ASH GROVE CEMENT COMPANY

Subject: Comments on Draft Permit
Ash Grove Cement Company

NPDES No. AR.0042846

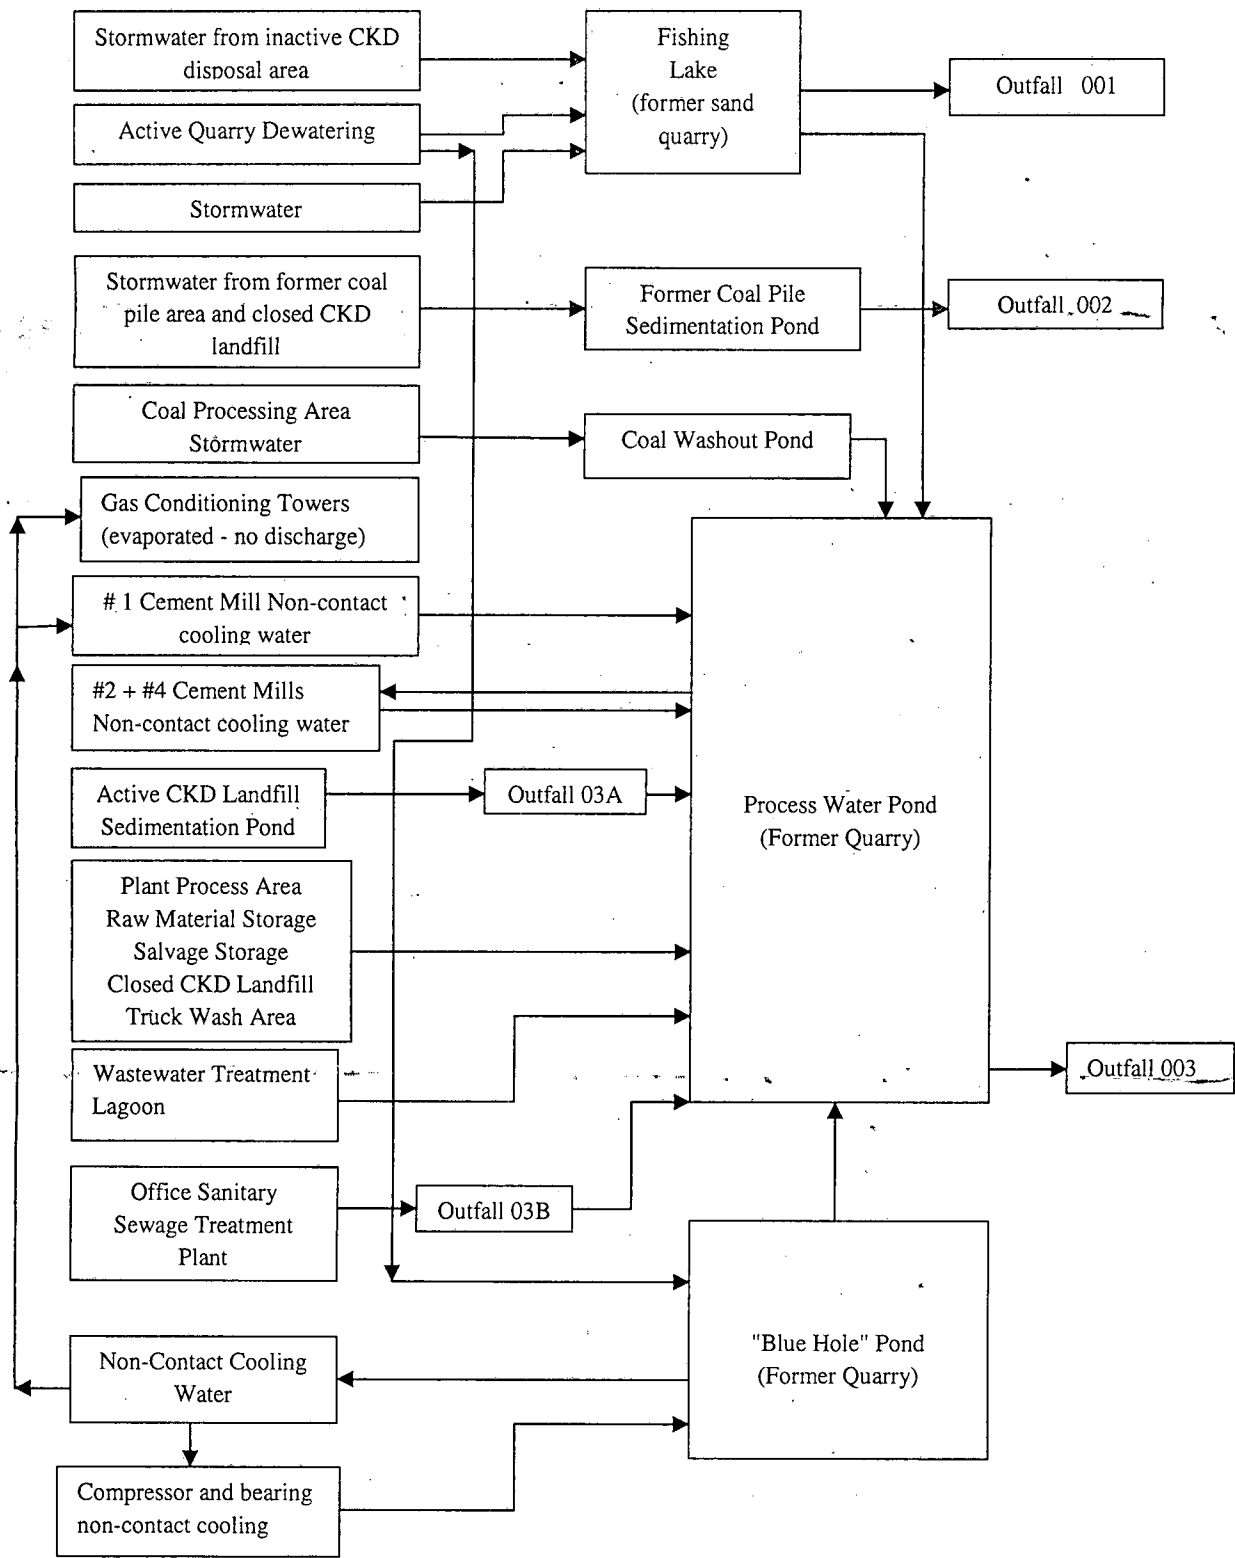
Since we had not been subject to the TSS mass limit in the past, the wastewater flow diagram submitted with the application was little changed from previous renewal applications. We have attached a revised Wastewater Flow Diagram that more clearly depicts the water flow used at the facility. Clearly, the vast majority of the water balance deals with runoff from materials storage piles runoff for which only 40 CFR 411 Subpart C is applicable. This circumstance was noted in Section IV of the ELG (page 30) as the reason for the establishment of the Subpart C subcategory:

As you know Ash Grove has recently replaced the old production process, termed a "wet process" with a dry pre-calciner pyroprocess. As can be seen on the attached schematic, the only "process water" that is re-circulated through the "Process Water Pond" (Outfall 003) is the non-contact cooling water from Cement Mills #2, and #4. Mill # 4 only operates when a production surge exceeds the capacity of Mill # 1. Mill # 2 is only operated an average of 5-7 days per month to manufacture Masonry Cement. Mills # 2 and # 4 rarely operate at the same time (due to power demands). Since the non-contact cooling water is re-circulated, Ash Grove does not believe that it is picking up contaminants that are being released to the environment as was contemplated in the January 1974 Effluent Limitations Guideline (ELG), i.e. there is no net increase in loading of TSS. The vast majority of source water to Outfall 003 is runoff from material storage piles.

As was discussed on the 18th, the Statement of Basis and the permit contain wastewater source, "Chalk Dryer Wet Scrubber Discharge" that is no longer in service. It was removed with the new plant construction. On the Public Notice Page, the Statement of Basis, Section 10 C. and in the draft permit Page 3 of Part IA all list "chalk dryer wet scrubber discharge", and "truck washout water" as sources in Outfall 003. The only "truck wash water" would be generated at the maintenance shed area where it goes through a settling pit and oil/water separator before being discharged to the "Blue Hole". The attached Wastewater Flow Diagram revision, mentioned above, reflects this change.
